Field Memorandum

To: Mr. Steve Norcini
 Cc: Mr. Robert Zienkowski, Mr. Rodger Phillips
 Date: August 29, 2016
 Site: VU – Buffer /Parking lot
 Reference: Vehicular light penetration to adjacent properties.

Villanova University
 W. Lancaster Ave. Parking
 Villanova, PA, 19383

L1.0
 Sheet No. 32 of 34
 Copyright © 2015 Villanova University. All rights reserved.
 Villanova University is a registered trademark of Villanova University.

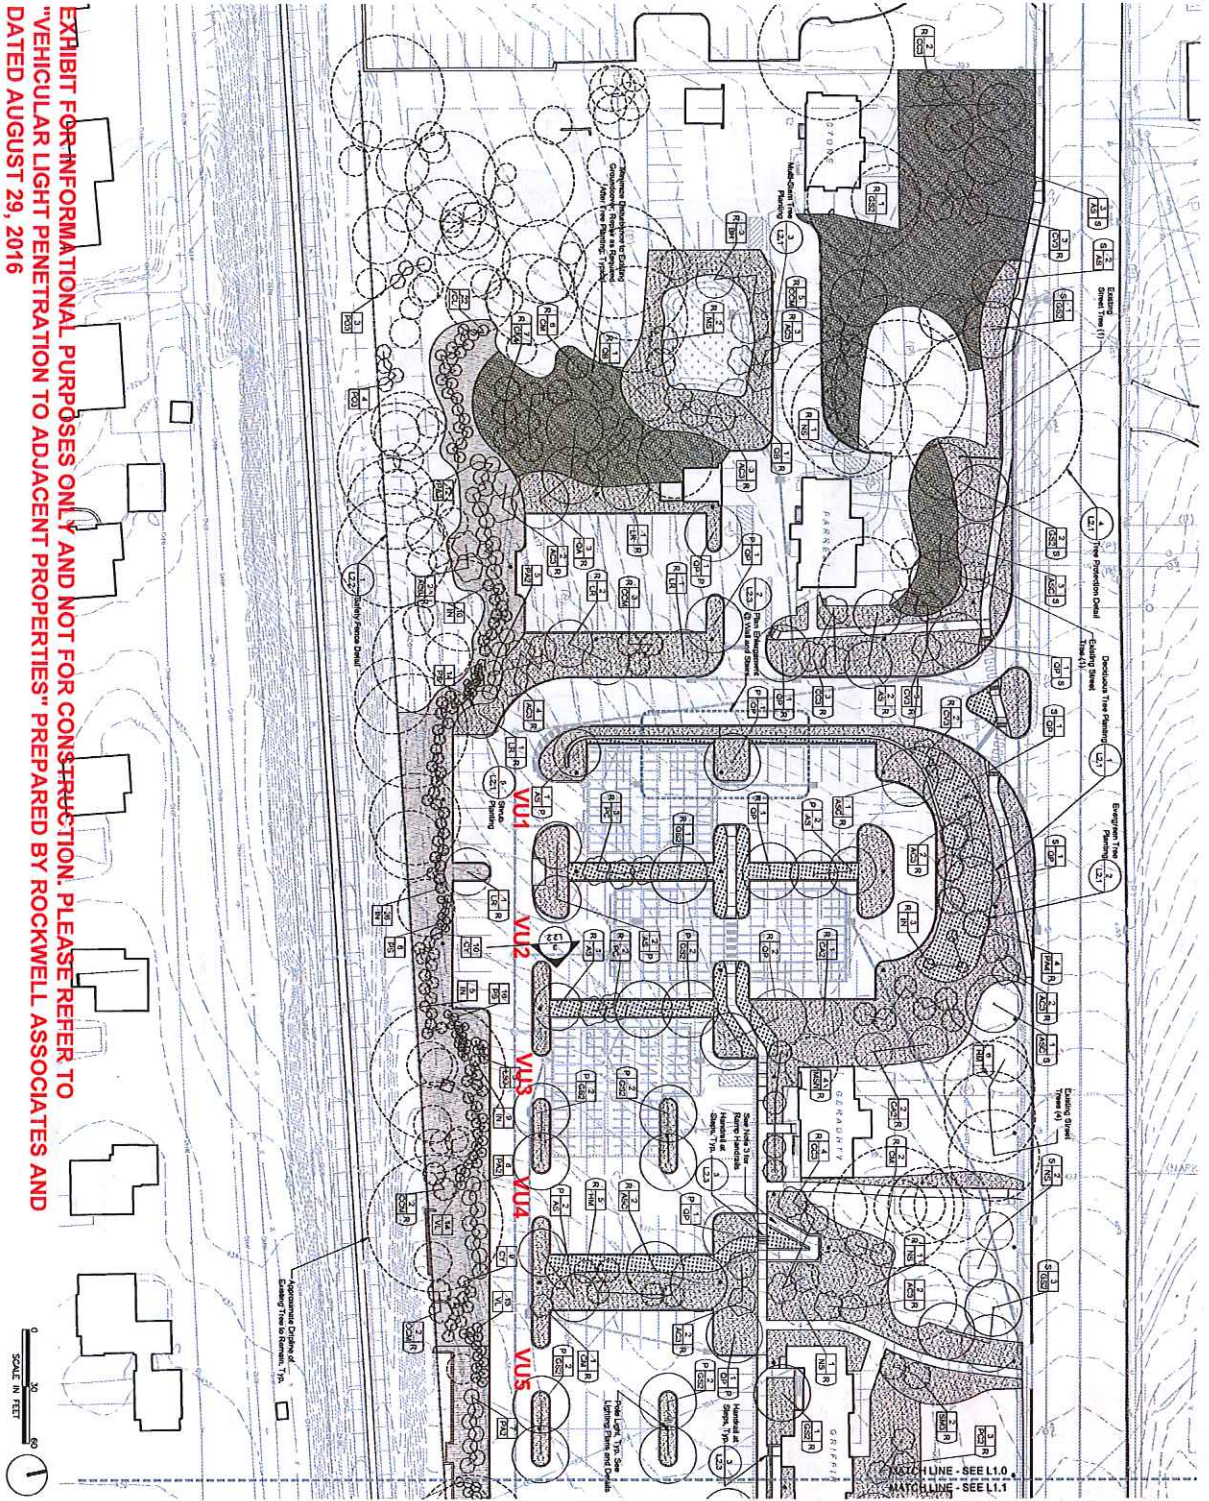
Parcel	Headlight Measurements (height at above road grade)	Adequacy of Coverage	Management	Notes
VU8	High beam - 96" Low beam - 27"	Inadequate	Add 5 evergreen trees	To be field located by Rockwell

Parcel	Headlight Measurements (height at above road grade)	Adequacy of Coverage	Management	Notes
VU10	High beam - 89" Low beam - 45"	Inadequate	Transplant shrubs and add 5 new evergreen trees	Monitor health of Plants

It was evident that most of the planting buffer is satisfactory at its immature state. However, adjustments are required at parcels 8 and 10 which are located at the east end of this buffer near the new entrance route. These will require additional trees.

L1.1

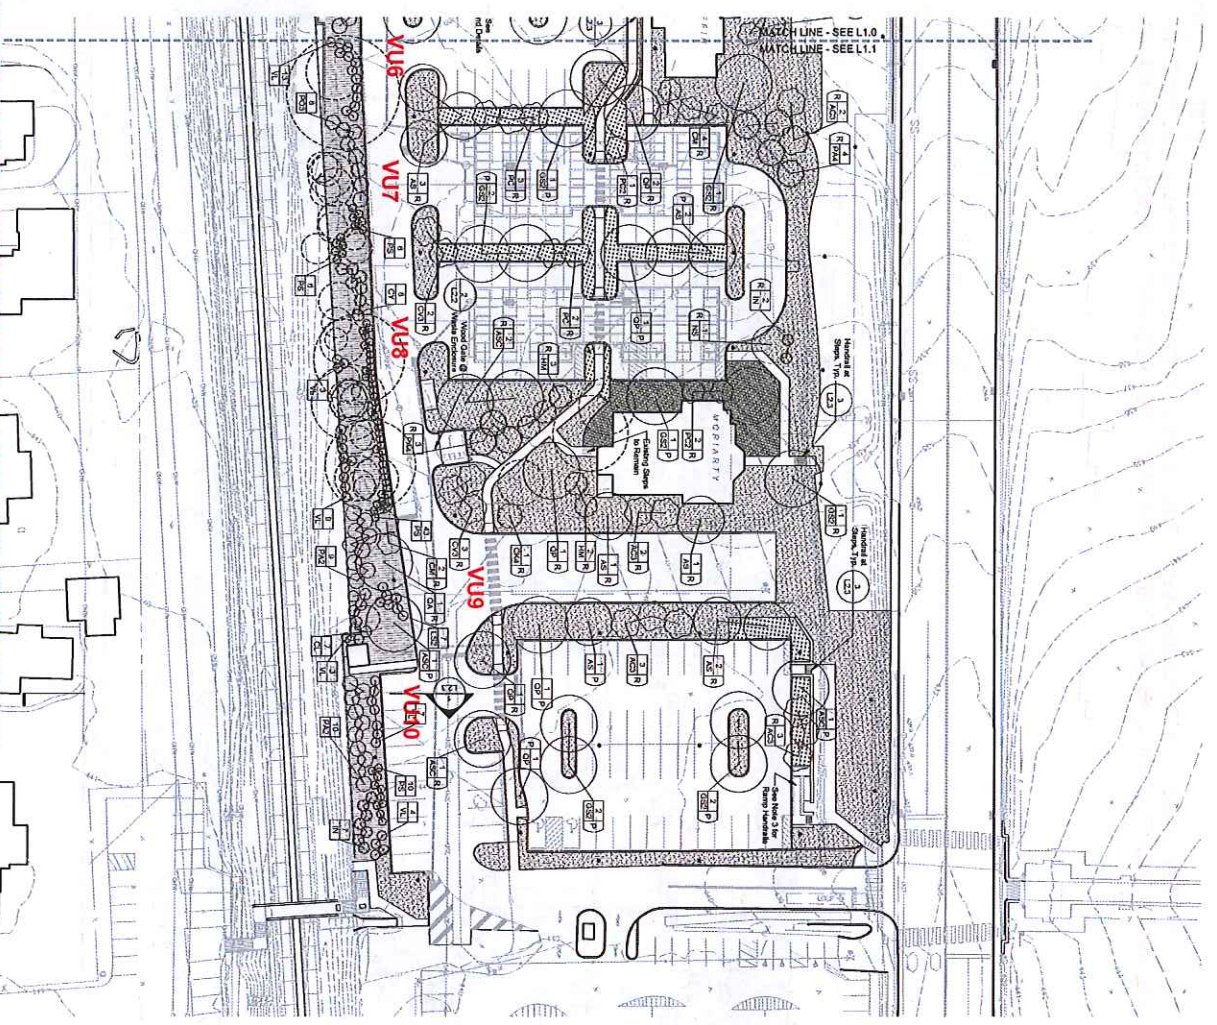
EXHIBIT FOR INFORMATIONAL PURPOSES ONLY AND NOT FOR CONSTRUCTION.
 PLEASE REFER TO "VEHICULAR LIGHT PENETRATION TO ADJACENT PROPERTIES"
 PREPARED BY ROCKWELL ASSOCIATES AND DATED AUGUST 29, 2016.
